CITY OF ALBUQUERQUE

Chick-fil-A Gibson, 1600 Gibson Blvd. SE

Traffic Circulation Layout

Engineer's Stamp Dated 05-05-15 (M15-D012C)

C-2.0

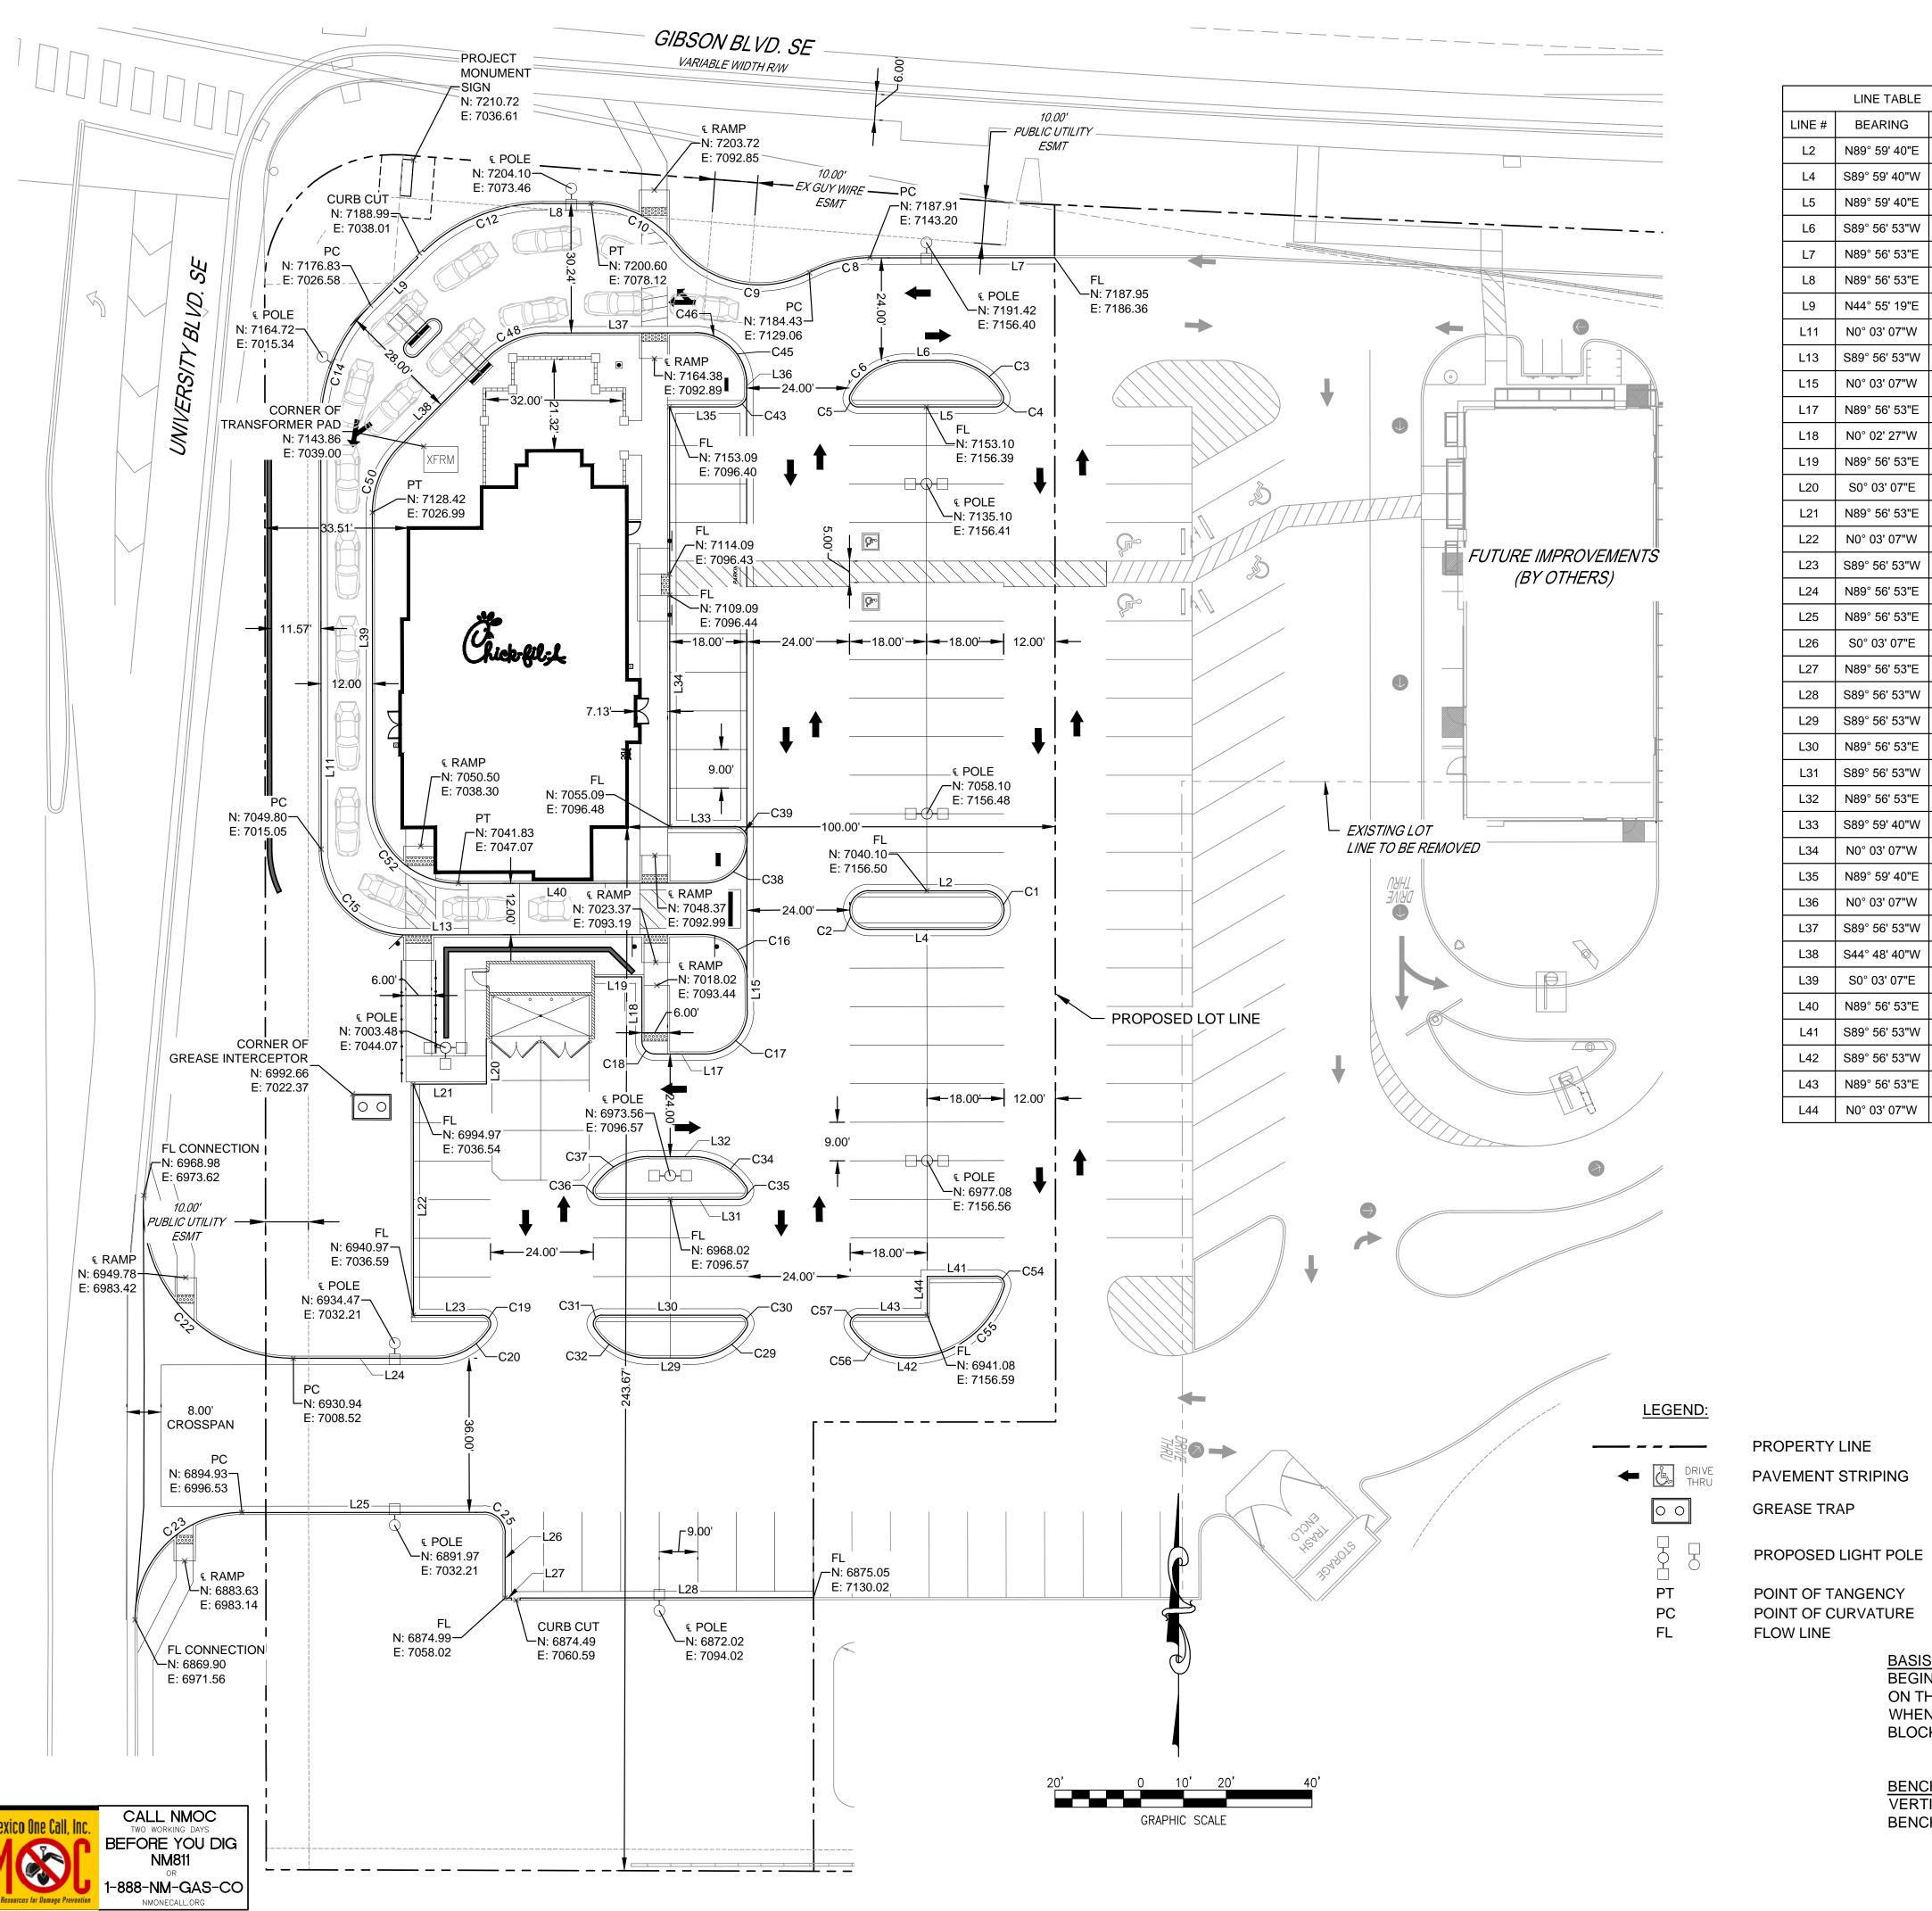
The TCL submittal received 05-07-15 is approved for Building Permit. A copy of the stamped and signed plan will be needed for each of the building permit plans. Please keep the original to be used for certification of the site for final C.O. for Transportation.

UNIVERSITY BOULEVARD STRIPING

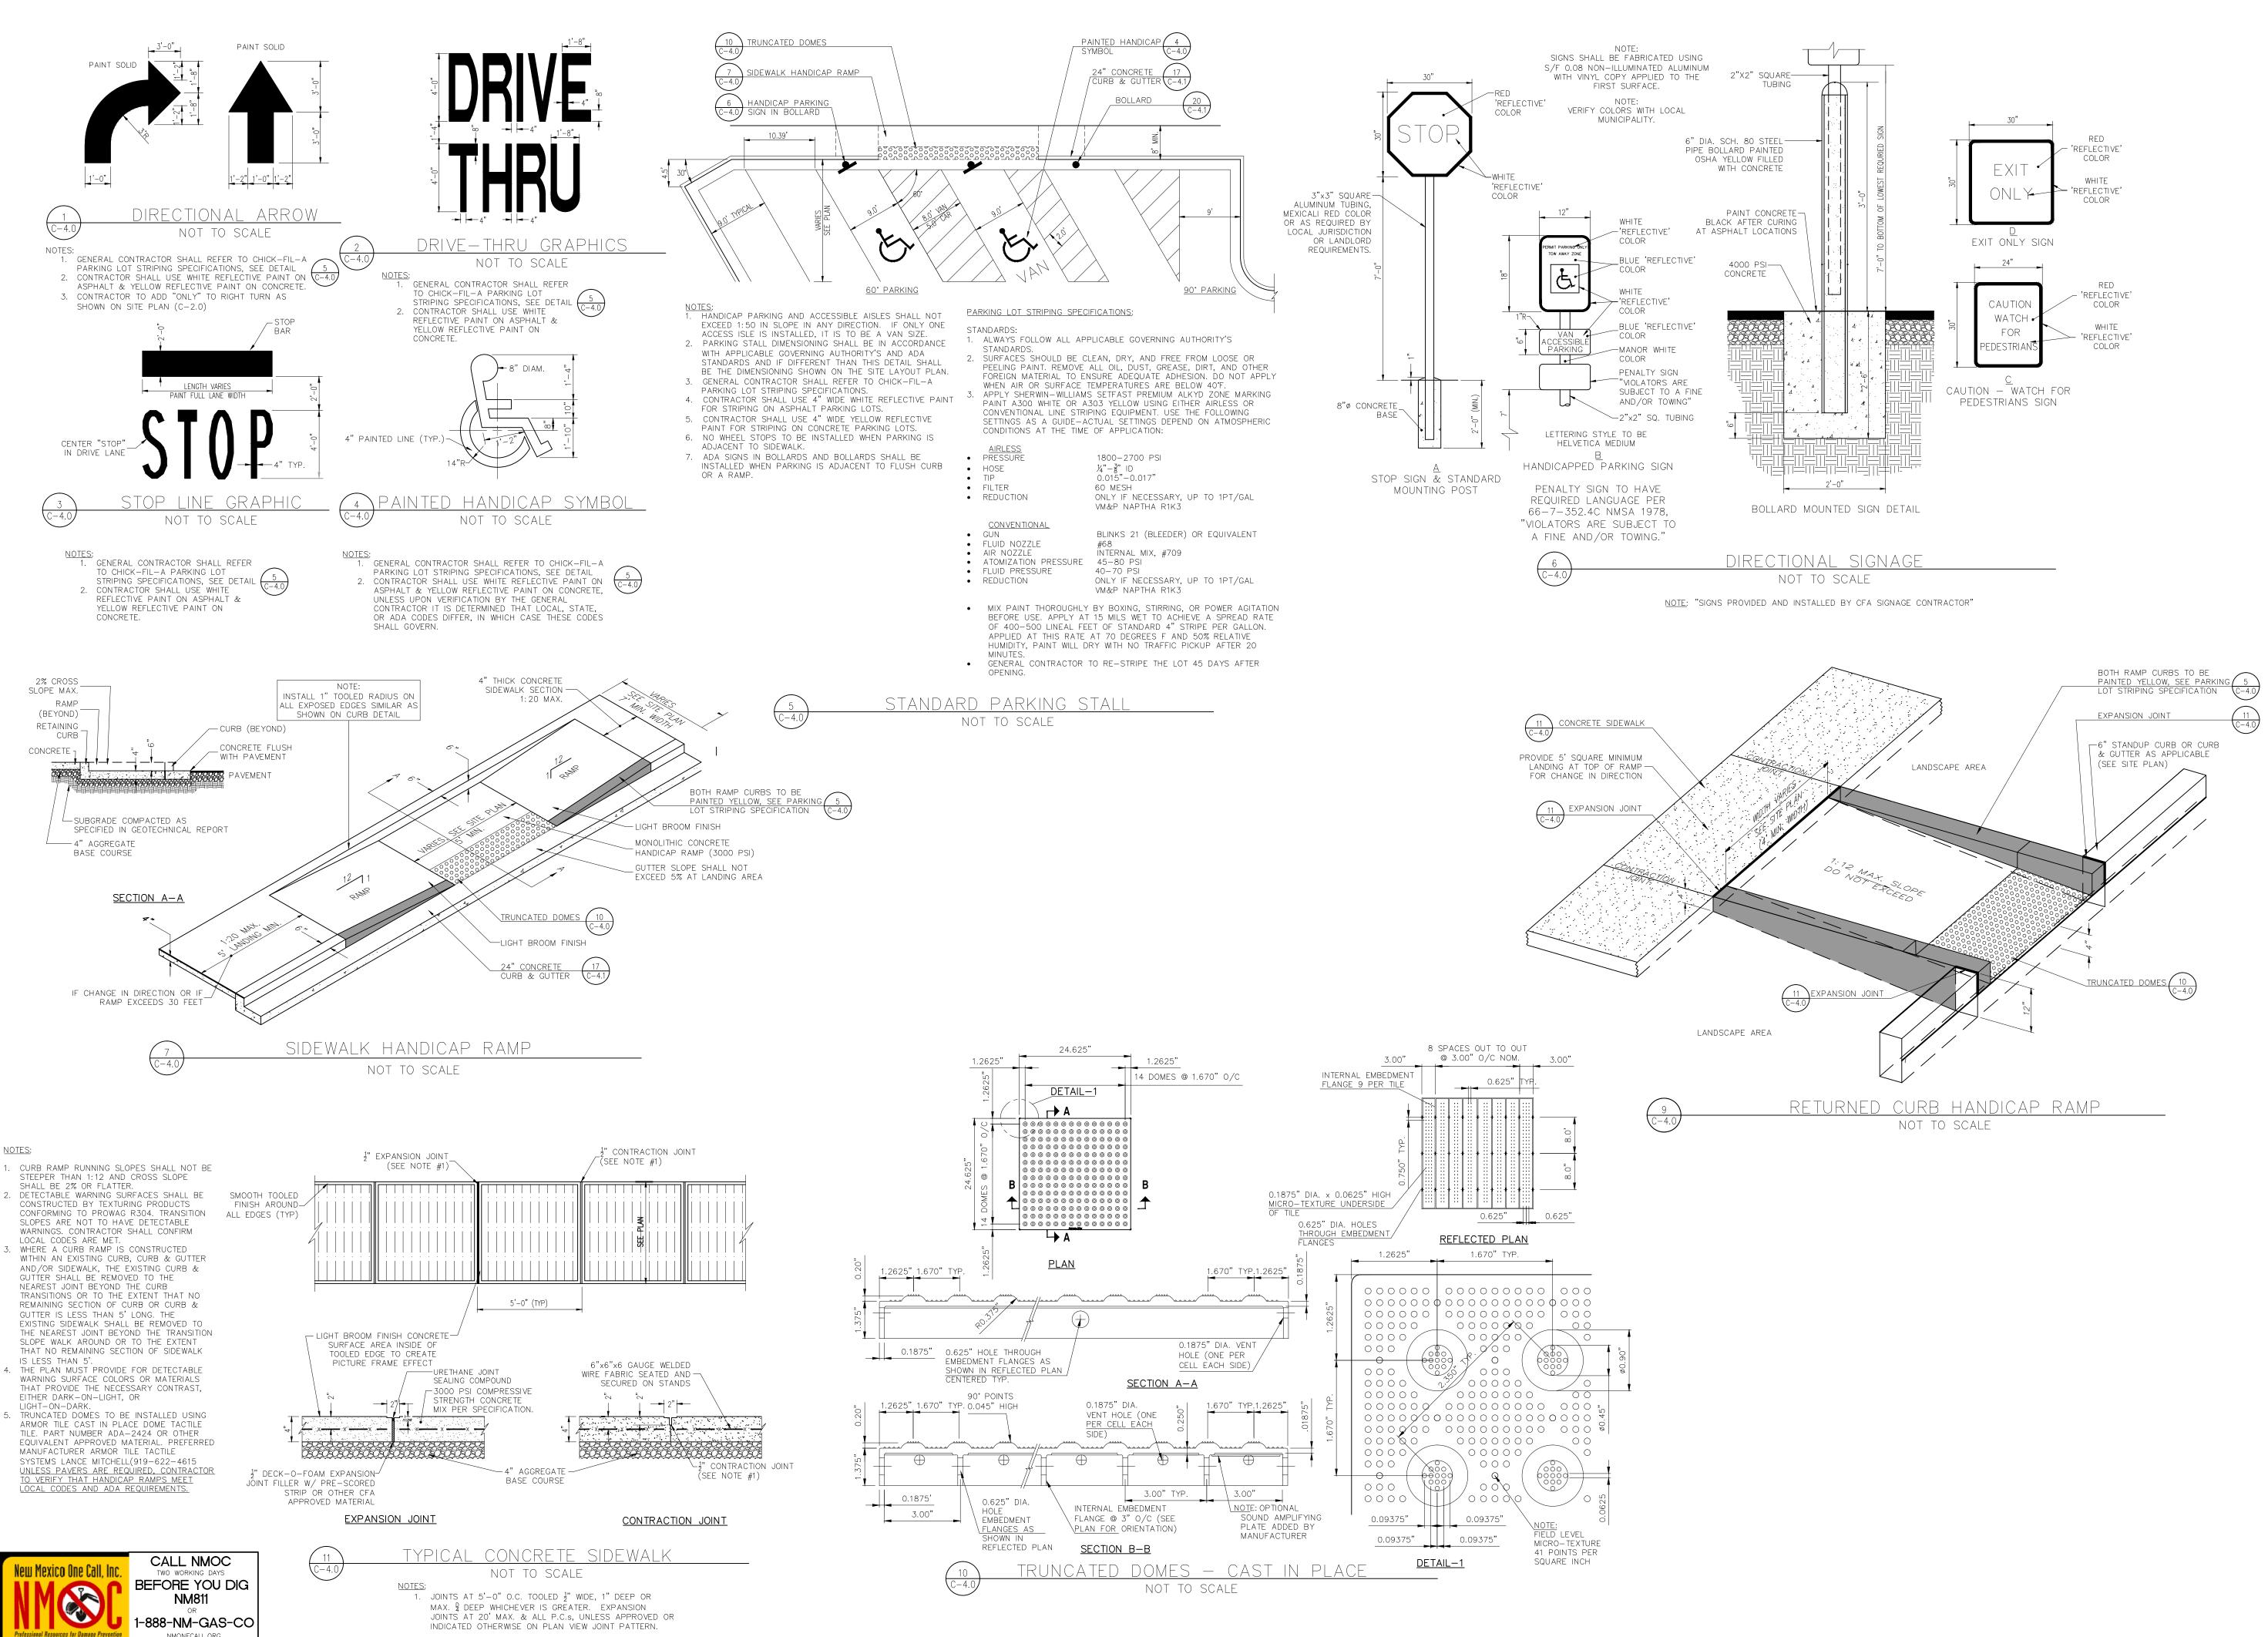
Additionally, a Certificate of Occupancy will not be issued until the work order is completed for the required work on University Boulevard as shown as part of the Traffic Impact Study dated May 12, 2015. Work Order drawings shall include striping work and median work necessary for extension of the northbound left-turn lane onto University Boulevard and the center dual left-turn lane north of Driveway "A" as shown on Page A-48 (Attached).
